Department of Environment, Land, Water and Planning Victoria:

*Walmer Street
Bridge
Engagement
Report*

October 2016

**RE: 607-627 VICTORIA STREET, ABBOTSFORD (THE PARK HOUSE)
RESPONSE TO BICYCLE NETWORK**

Figure 1: Pedestrian and Bicycle Links

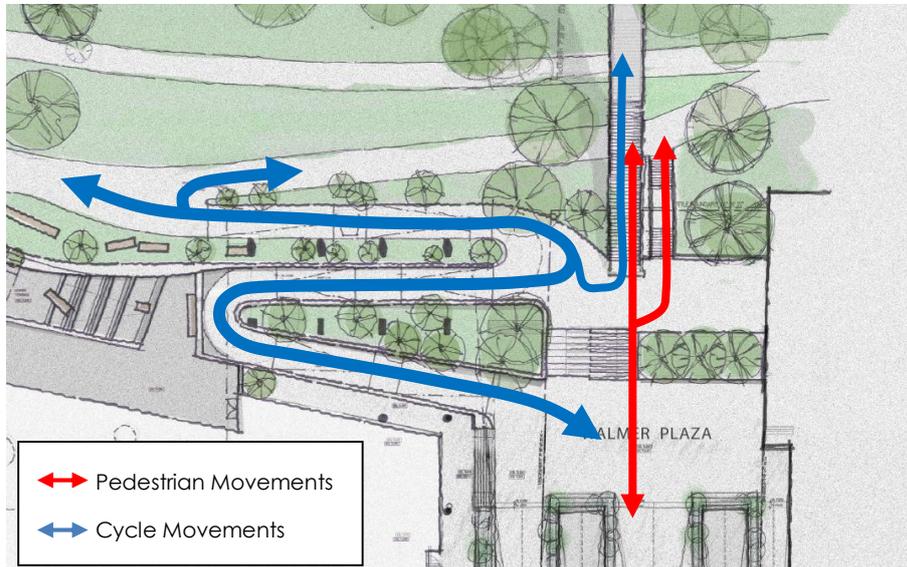
“The riders from the Main Yarra Trail, Walmer bridge and the switchback ramp are all funnelled into a small area—this creates a worrying conflict zone given the volume of riders as well as pedestrians and the disabled passing through the area.”

The layout of the bicycle ramps and pedestrian steps/paths have been revised to reduce the potential for conflict between each of the users. Specifically, the changes include the following:

- Widening of the bicycle paths to 3.1m
- Realignment of the bicycle paths at the entrance to the Walmer Street bridge
- Increased turning radii at the switchbacks

The revised layout which separates bicycles using the switchback ramp from pedestrians using the stairs is considered an appropriate design outcome.

Figure 3 - Path capacity for paths with 90/10 directional split.

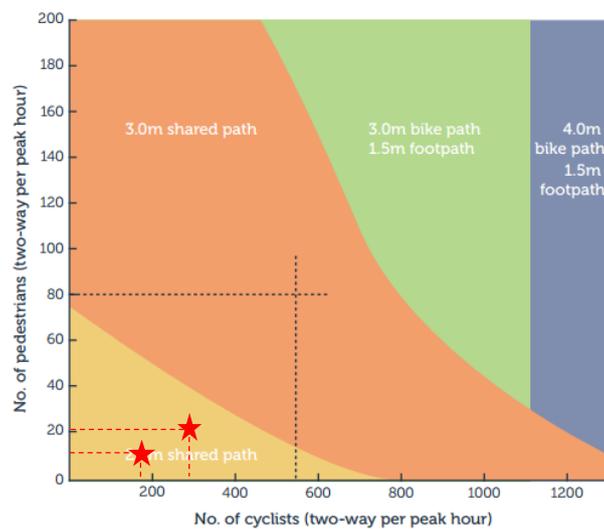
“The switchback ramp as a connection from the bridge level (Lower Plaza) to Walmer Plaza significantly reduces the level of service for riders as they will now have to navigate through a tight angled ramp. The switchback angles through this section will make it difficult for bike riders to pass each other coming in opposite directions and the Landscape plan even refers to it as a ‘pedestrian ramp’. There is currently a switchback ramp in place connecting the Main Yarra Trail to Walmer Street, however this was built a number of years ago to a now-outdated standard and is unacceptable in 2016.”

Applying the existing demands to Figure 2 (as shown by the stars) above indicates that a 2.5m shared path would be an appropriate width through each of the switchback designs. A 2.5m wide path could cater for significant growth in existing cycling demands at each of the switchbacks.

The proposed switchback is 3.1m wide or 2.5m effective width with 300mm widening to the adjacent garden beds/landscaping areas.

Based on the existing bicycle and pedestrian demands the proposed shared path width of 3.1m (2.5m effective width) is considered an appropriate design outcome and consistent with the relevant VicRoads design guidelines and other switchback designs in Melbourne.

VICTORIA STREET / BURNLEY STREET / WALMER STREET
YARRA CITY
TRAFFIC SIGNAL PLAN

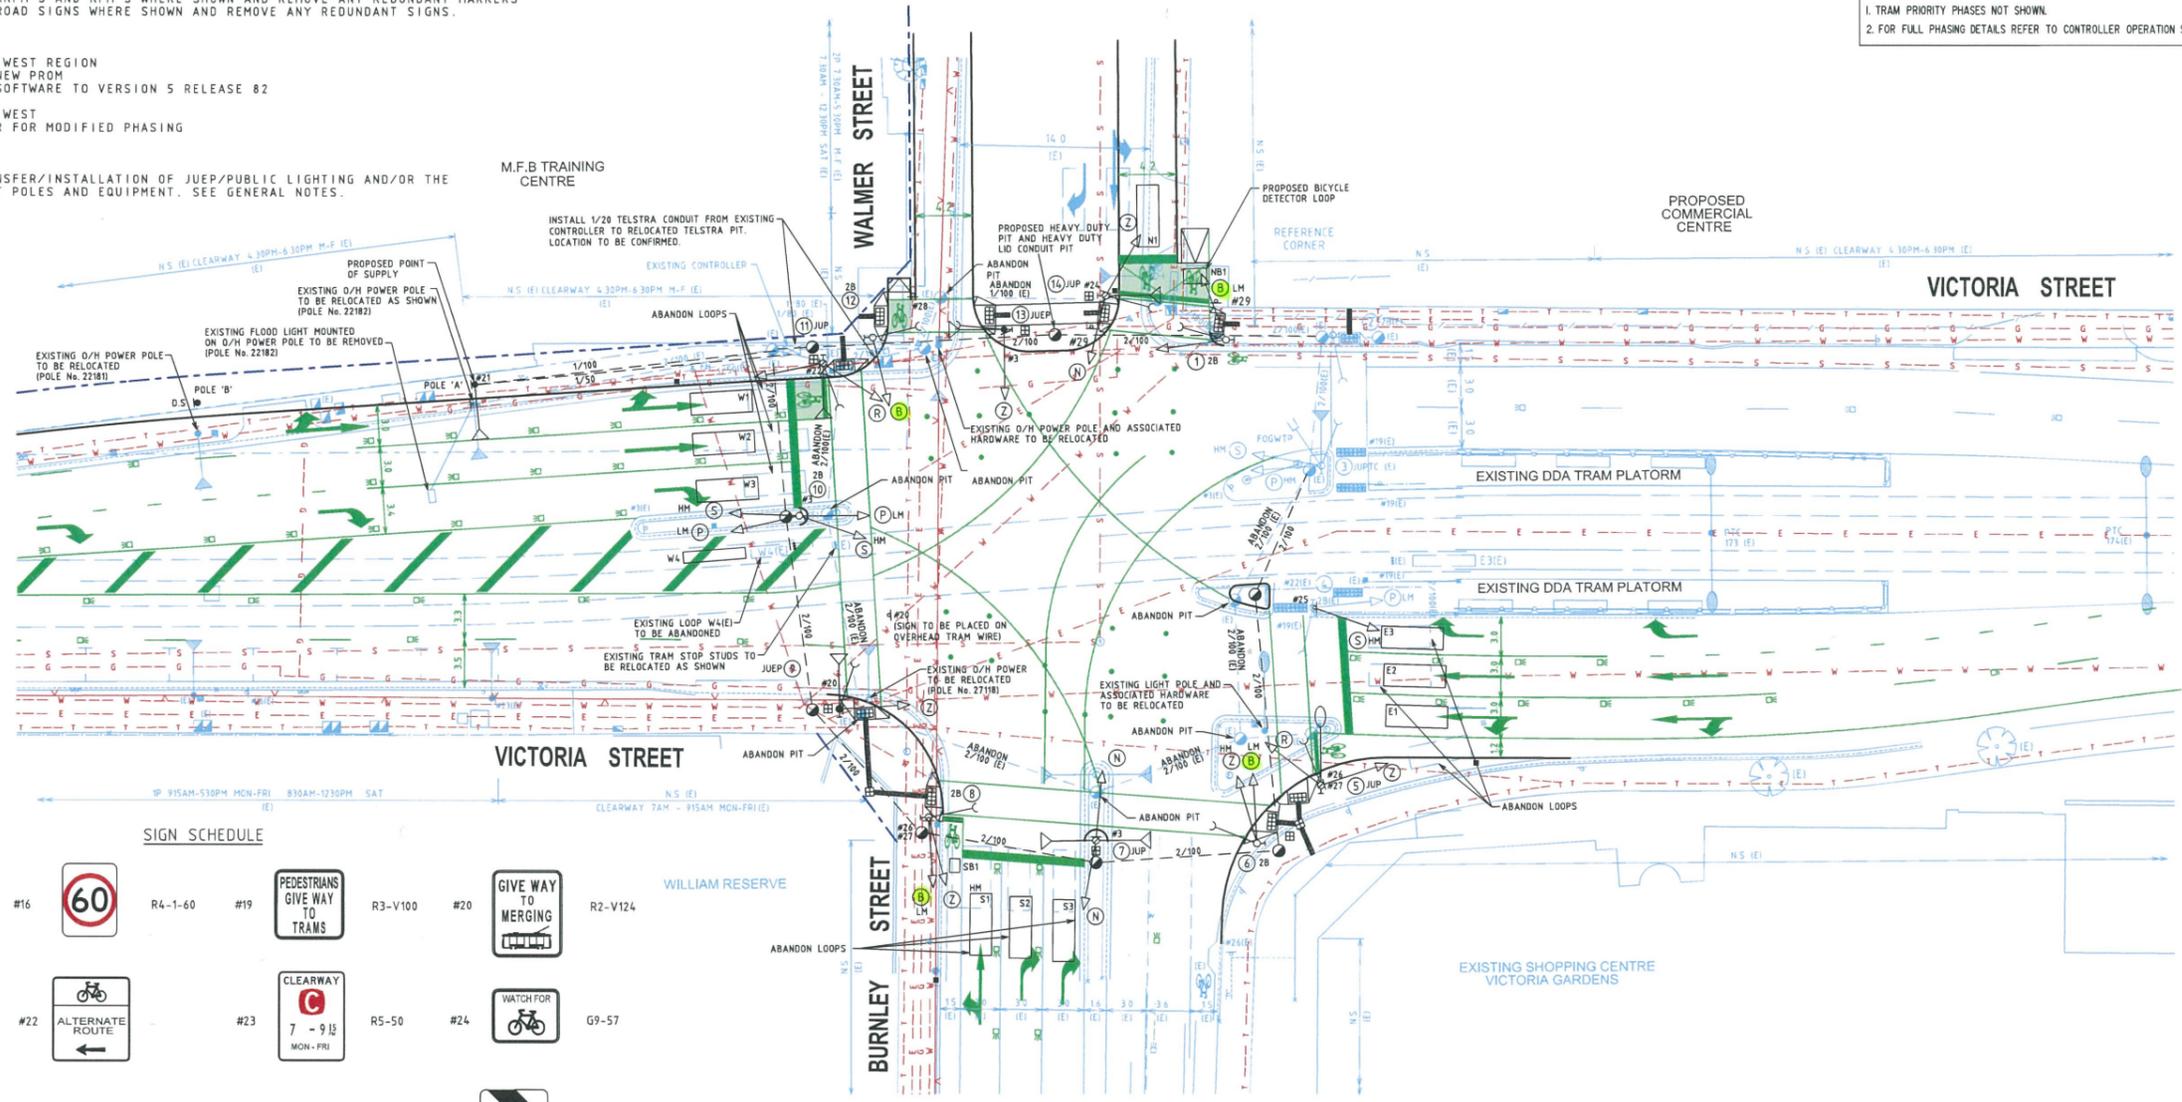
“A better design outcome also needs to be considered for the connection of riders from Walmer Street Plaza to Victoria Street. This should include bike lanterns at the intersection.”

A functional layout plan and associated traffic signal layout plan (provided at Attachment 3) for the Victoria Street / Burnley Street / Walmer Street intersection has been approved by VicRoads.

The traffic signal layout plan indicates that bicycle specific lanterns are provided for bicycles approaching the intersection from Walmer Plaza and Burnley Street. Cyclist movements on the Victoria Street approaches would occur concurrently with vehicle movements, consistent with the current arrangements.

Given the volume of cyclists, the provision of bicycle lanterns on the north and south approaches to the intersection is considered an appropriate design outcome.
